9.4 Air Conditioning, Heating, Cooling and Ventilating Systems

The information in this section of the reference ABWR DCD, including all subsections, tables, and figures is incorporated by reference with the following departures and supplements.

Figure 9.4-2c Electrical Building HVAC System Diagram
Turbine Building Electrical Equipment Areas (EEA) HVAC System Diagram

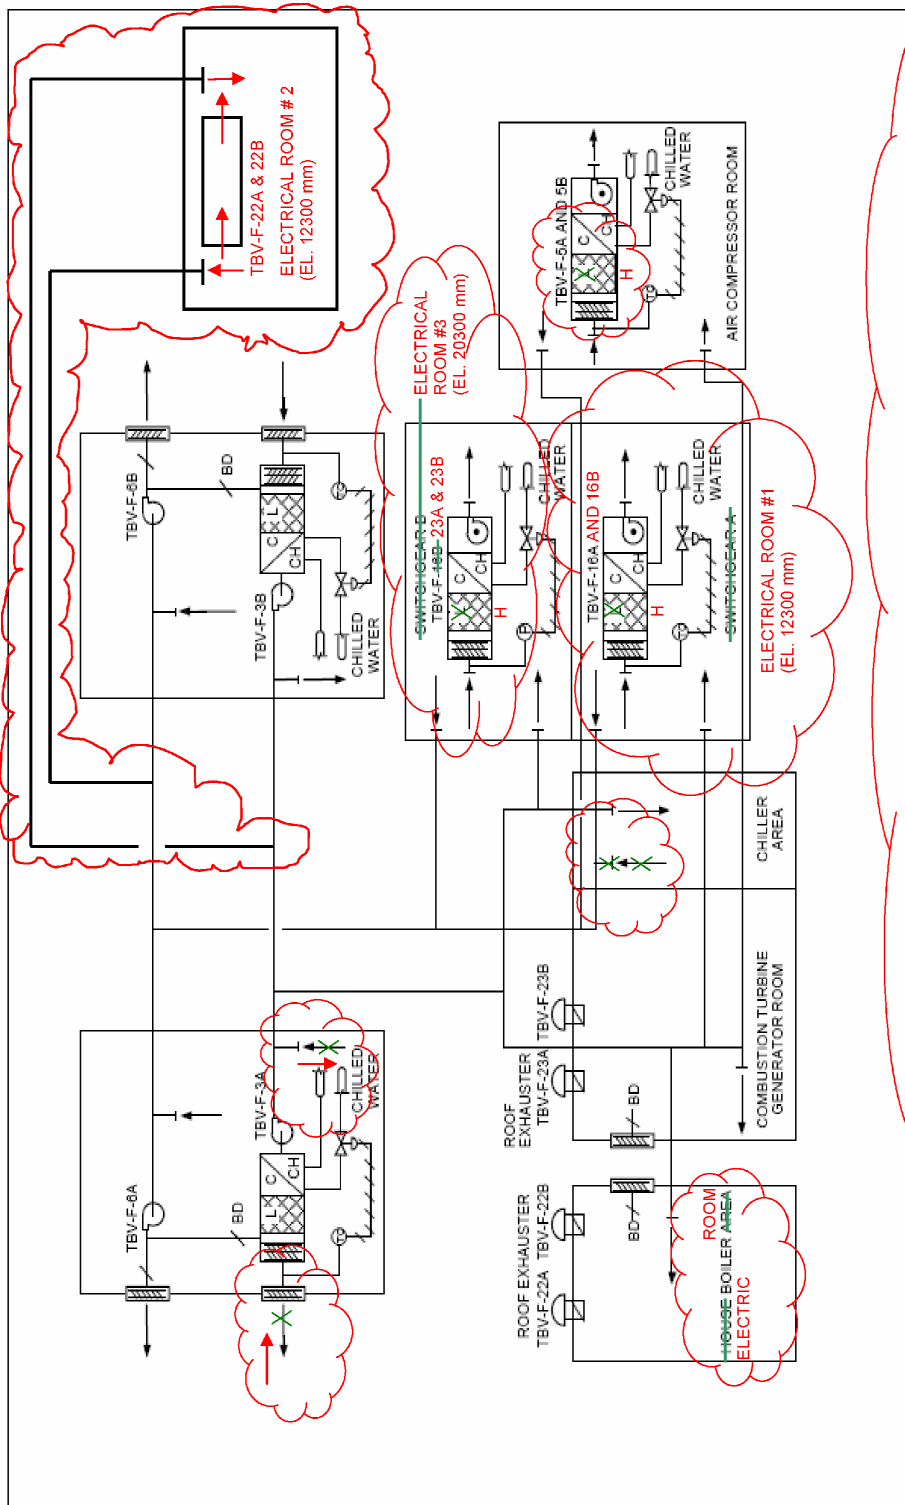
STD DEP 9.4-4 (Tables 9.4-3, 9.4-5, 9.4-5a, 9.4-5b, 9.4-5c, and 9.4-5d), (Figures 9.4-2a, 9.4-2b Sheet 2, and 9.4-2c)

STD DEP 9.4-4

9.4.4.2.2 ~~E/B~~ EEA HVAC General Description

The ~~E/B~~ EEA HVAC schematic diagram is shown on Figure 9.4-2c.

9.4.4.2.2.1 Electrical Building Equipment Areas HVAC System

The Electrical Building Equipment area HVAC System is provided with two 100% capacity air supply fans and two 100% capacity exhaust fans.

The air supply fan draws outside air through louvers, control dampers, low efficiency filters, and chilled water coils, and discharges air directly into the ~~switchgear~~ electrical rooms, chiller, combustion turbine generator, house electric boiler room and air compressor rooms. Return air Ductwork ductwork and bypass dampers are is provided to allow recirculation of air from the switchgear electrical rooms and chiller rooms air compressor room.
